UNITED STATES PATENT AND TRADEMARK OFFICE

APPLICATION NO.	FILING DATE	FIRST NAMED INVENTOR	ATTORNEY DOCKET NO.	CONFIRMATION NO.
10/765,201	01/28/2004	Deepak Keshav Pai	12492.0274	7631
7590 07/30/2008				
Steptoe & Johnson LLP 1330 Connecticut Avenue, N.W. Washington, DC 20036				
EXAMINER				
CHANG, RICK KILTAE				
ART UNIT		PAPER NUMBER		
3726				
MAIL DATE		DELIVERY MODE		
07/30/2008		PAPER

Office Action Summary

DETAILED ACTION

FIG. IE

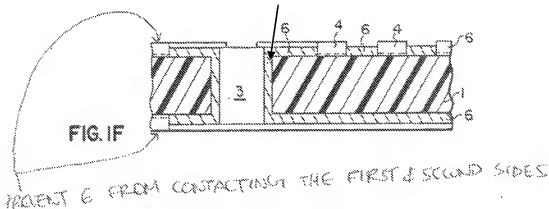
Bahrle discloses as follows: 4 is a photoresist; 3 is a hole; Figs. 1E-1F show exposing, developing and washing (Fig. 2B and claim 3); electroplating with copper 6; 5 is copper.

Substantially filled with 6

Bahrle's hole 3 is filled with 6.

As shown above, 4 covers the hole 3 and substantially prevents the second conductor from contacting the sides.
